A REQUEST FOR CONCEPT PLAN REVIEW APPROVAL BY:
Teton Partners, Ltd.
FOR: Cutthroat Creek Subdivision,
WHERE: 5375 N 2250 E & 5457 N 2250 E
 Prepared for the Planning & Zoning Commission
 Public Hearing of January 13, 2015

UPDATED 1/5/2015
TO INCLUDE
PUBLIC
COMMENTS
(ATTACHMENT 13)

REQUEST: Teton Partners, Ltd. is proposing a 26 lot (241.22 acres) subdivision. The residential lots will range from 2.73 acres to 64.86 acres. The proposed subdivision is adjacent to South Leigh Creek, and it is being designed in such a way to reduce impact to the natural resources and wildlife habitat in the area and preserve productive farmland.

**CUTTHROAT CREEK SUBDIVISION
CONCEPT MASTER PLAN**

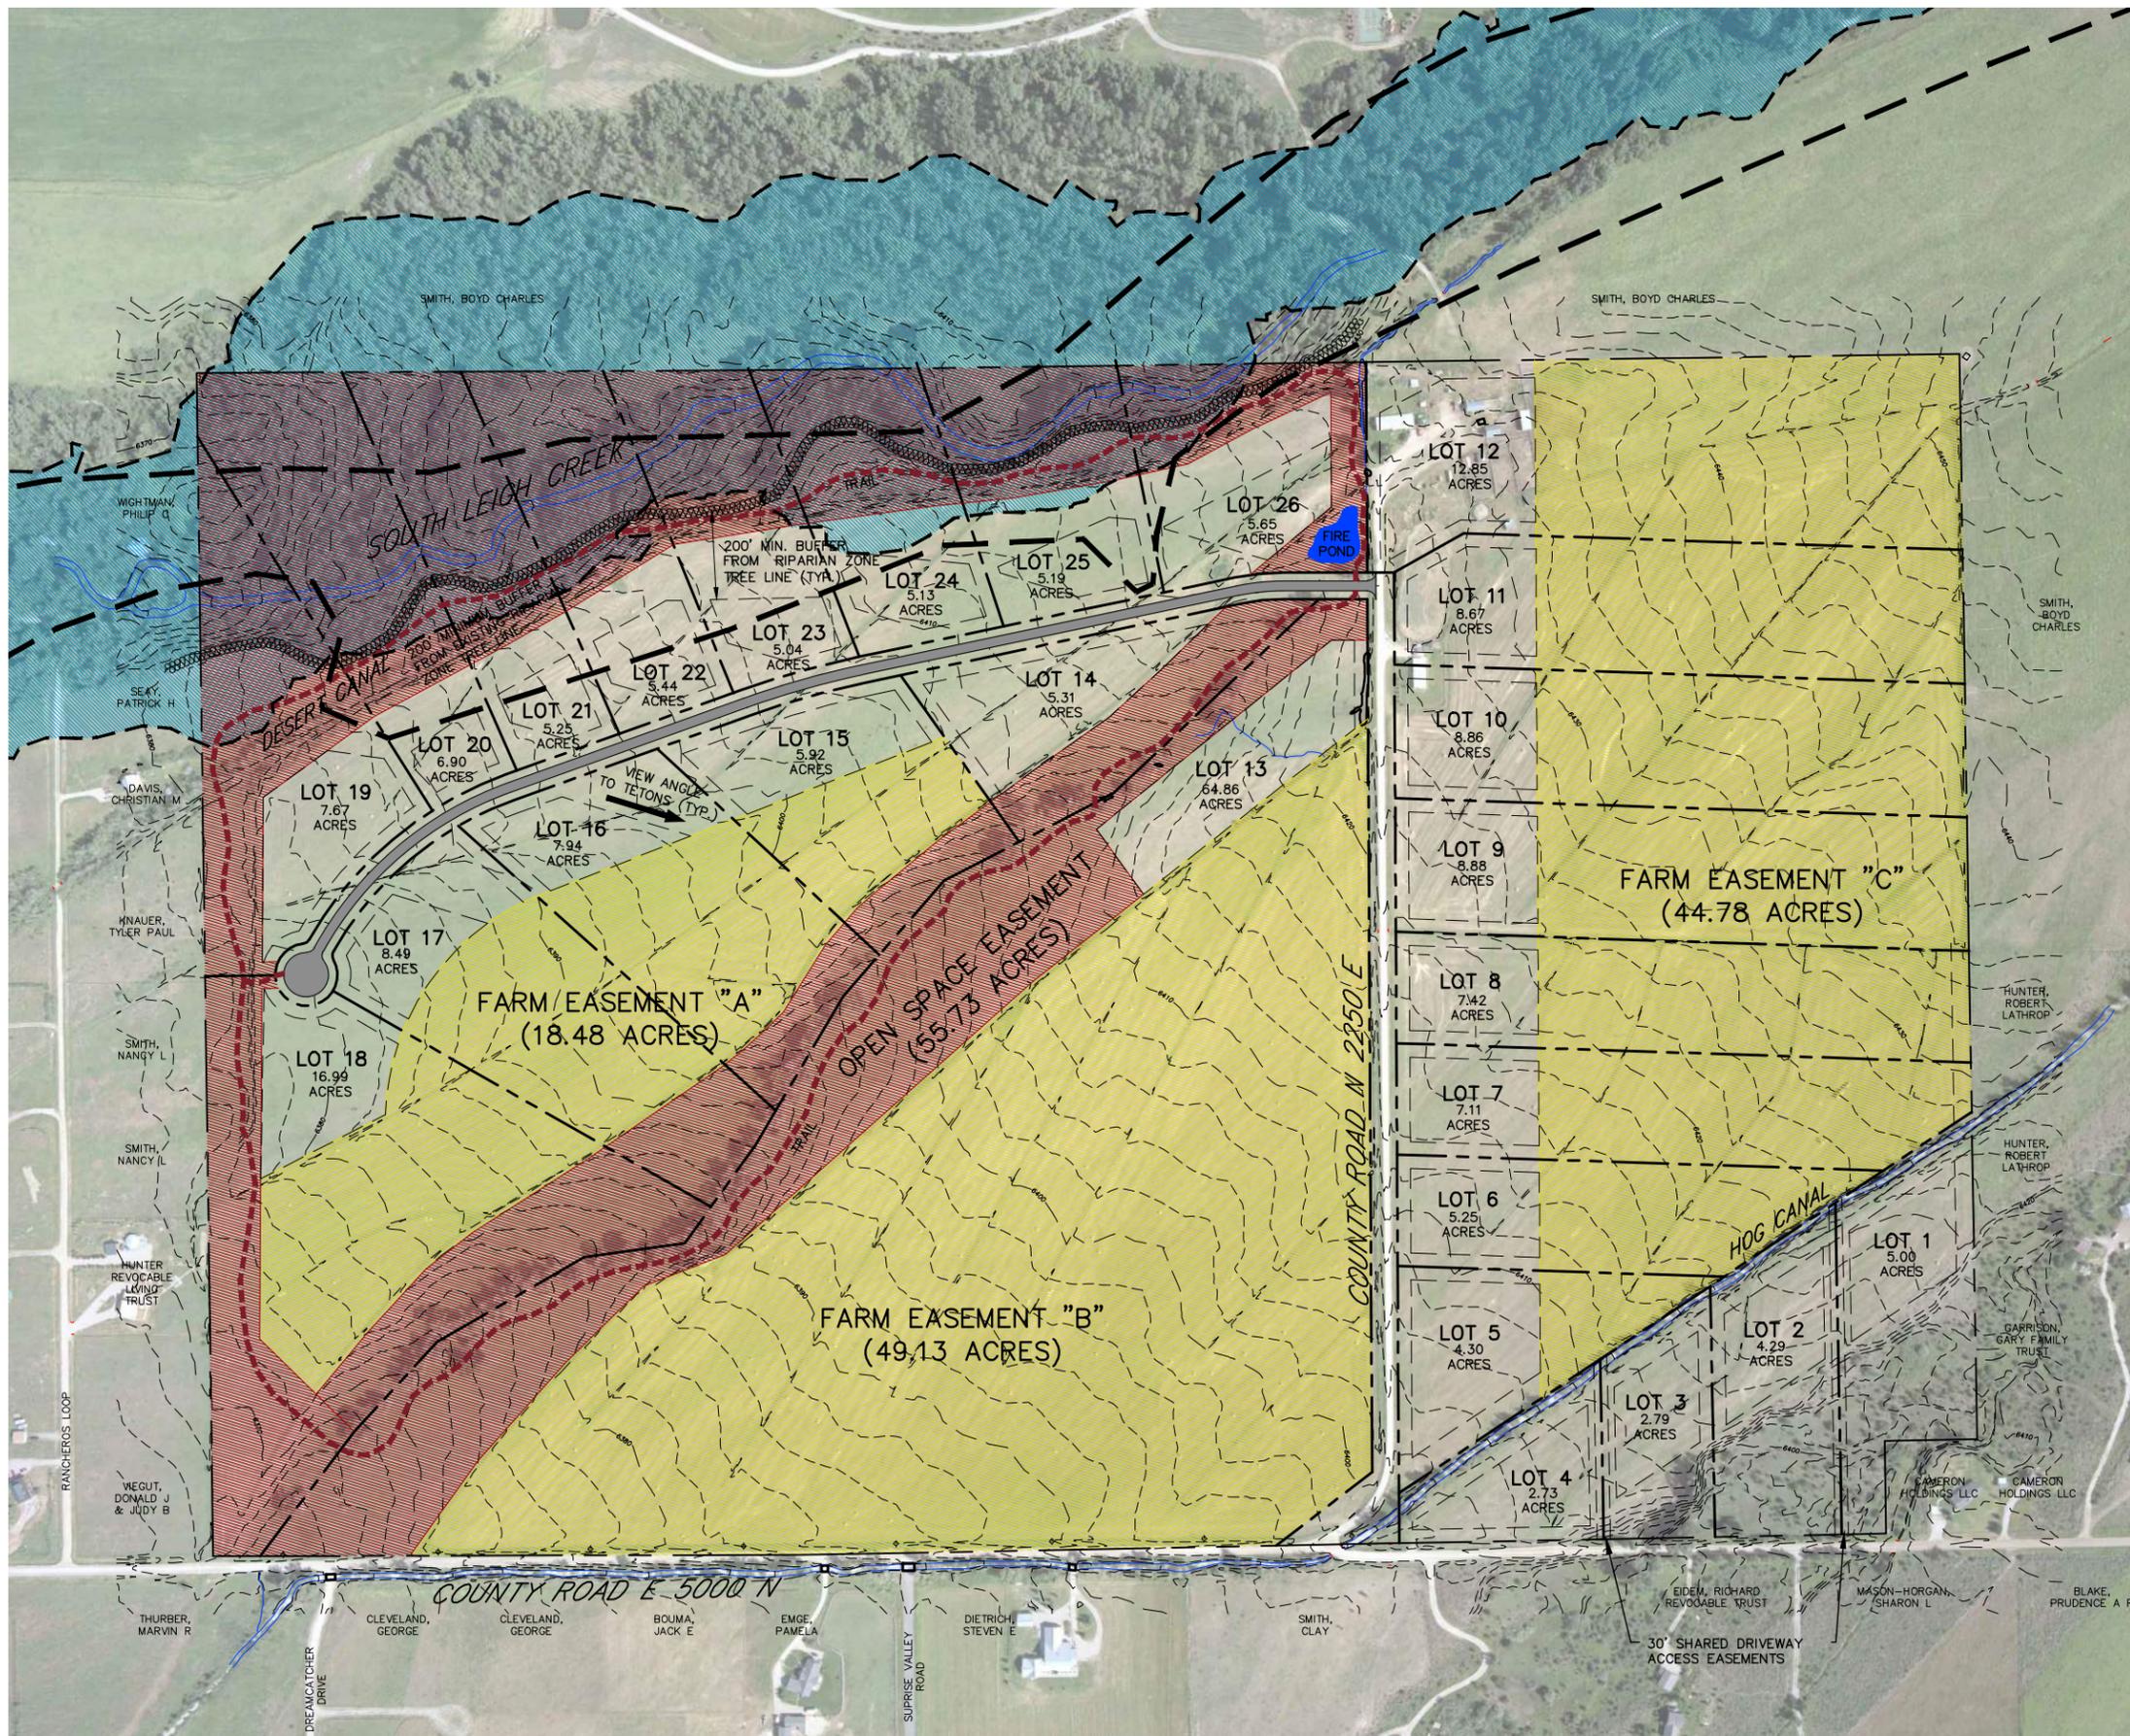
- *N2250E re-alignment:* I would prefer for the intersection of this road to be directly across from the driveway to the east or my preference would be moving the intersection farther to the west. Preferred minimum separation between access points is 300’.
- *Access for Lots 1-4:* I would also ask that you attempt to align with driveways to the south. I understand the minimum distance between driveways is currently not the minimum 300’ but I would encourage you to not make the situation any worse than it is if possible. One consideration might be to design an access from 2250E and have a shared drive run along the north property line of Lots 1-4.

- It seems clear that a far more sensible site plan that would be more in tune with the 'rural neighborhood' concept and certainly more environmentally responsible calls for a relocation of lots 1-4. Moving these four lots to Farm Easement "B" and adding the 14.81 acres to open space comes to mind. It would be far easier (cost effective) to create a road off of County Road 2250E to access the lots if they were located in Farm Easement "B". The proposed location of lots 1-4 is in a riparian zone that has never been cultivated and contains old growth trees, native foliage and is home to a wide variety of wildlife. This is the only area of the southern portion of the subdivision that is in an intact natural state. Transferring this small segment (six percent) of native habitat for a more conducive segment of marginal farm land is a logical, cost effective and environmentally responsible change.

As a landowner in the Teton Rancheros Subdivision, I have several reservations concerning the development of the Cutthroat Creek subdivision. One concern is the development of building lots and roads directly abutting my property line. One of the reasons I purchased the property in Teton Rancheros was the uninterrupted view of the Tetons directly to the southeast. The current plan places lots 17, 18 & 19 directly to the east of my lot. The implementation of a cul-de-sac and several large residential structures would undoubtedly decrease the aesthetic view for the following landowners: Christian Davis, Nancy Smith, Tyler Knauer & The Hunter Living Trust. As a result I propose a farming easement be placed on the western part of the property from 5000N to the South Leigh Creek riparian corridor. Alternatively, increase the open space easement on the western edge of the
